Sewerage & Water Board OF NEW ORLEANS

Addendum No. 1

Your reference is directed to **Contract Number: 2026-SWB-12 (8174)** for Repairs to the Engineering Building at the Carrollton Water Plant which is scheduled to open at **11:30 a.m. CST** on **April 15, 2026**. This addendum provides for the following:

1280D15 - D

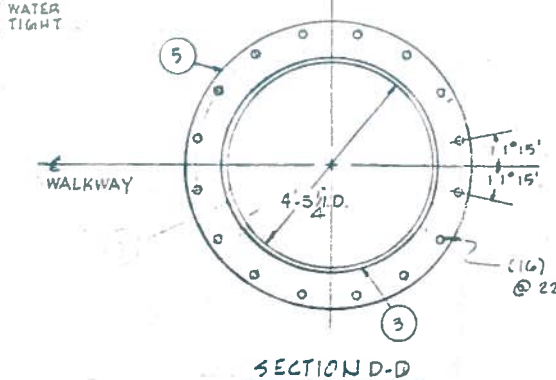
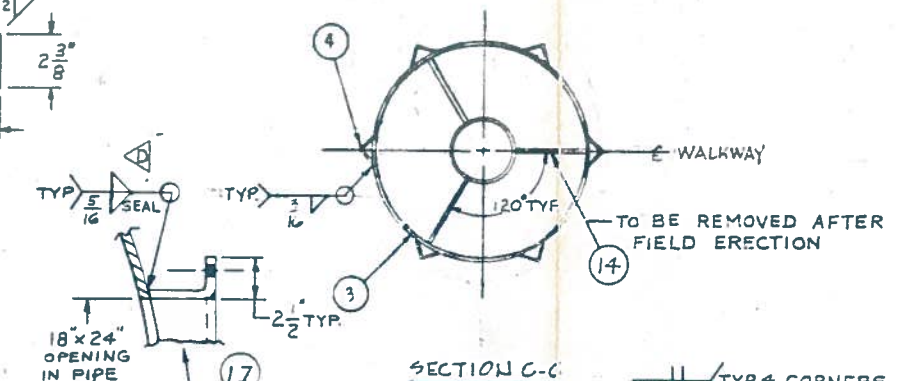
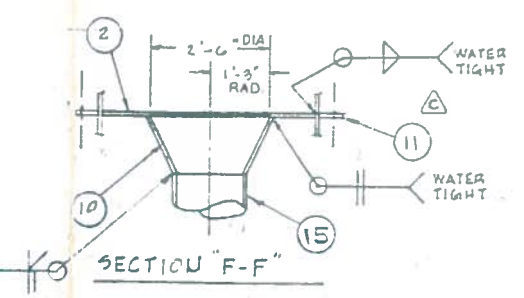
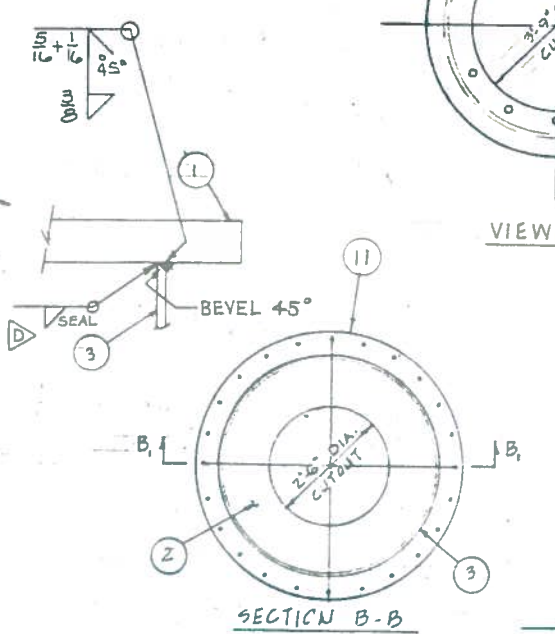
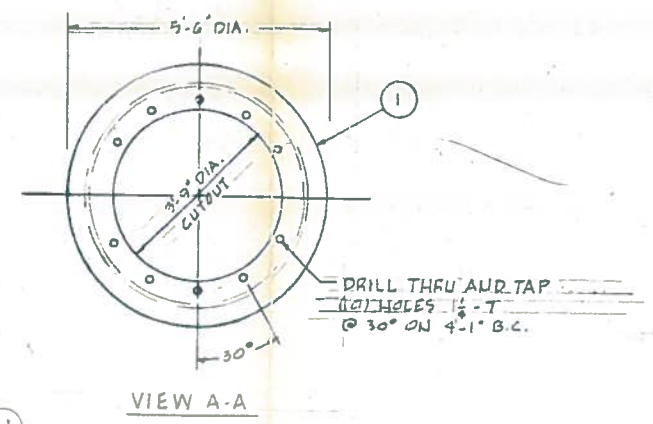
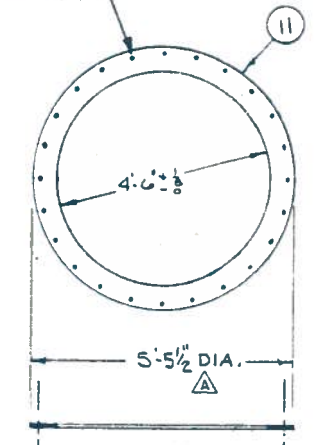
Please provide the information about the drivers on site to confirm that the proposed Kusters drivers are suitable for replacement.

No information was identified in the bid documents other than torque requirements. Can field measurements of the existing drive units be provided?

Refer to the Label Plate Notes and Attachment Notes provided with this clarification for available information on the existing drive units.

- Drawing No. 1280D15 Rev. D – Center Column Assembly 164'- 0" Clarifier B.F. Type H.D.
- Drawing No. 1280D22 Rev. B – Drive Cage 164'- 0" Clarifier B.F Type H.D

As the existing units are currently in operation, field measurements are not feasible at this time.

- ***Drawing No. 1280D15 Rev. D – Center Column Assembly 164'- 0" Clarifier B.F. Type H.D.***
- ***Drawing No. 1280D22 Rev. B – Drive Cage 164'- 0" Clarifier B.F Type H.D***
- ***Drawing No. 1275D48 Rev. H - Clarifier B.F. Type H.D. Layout***
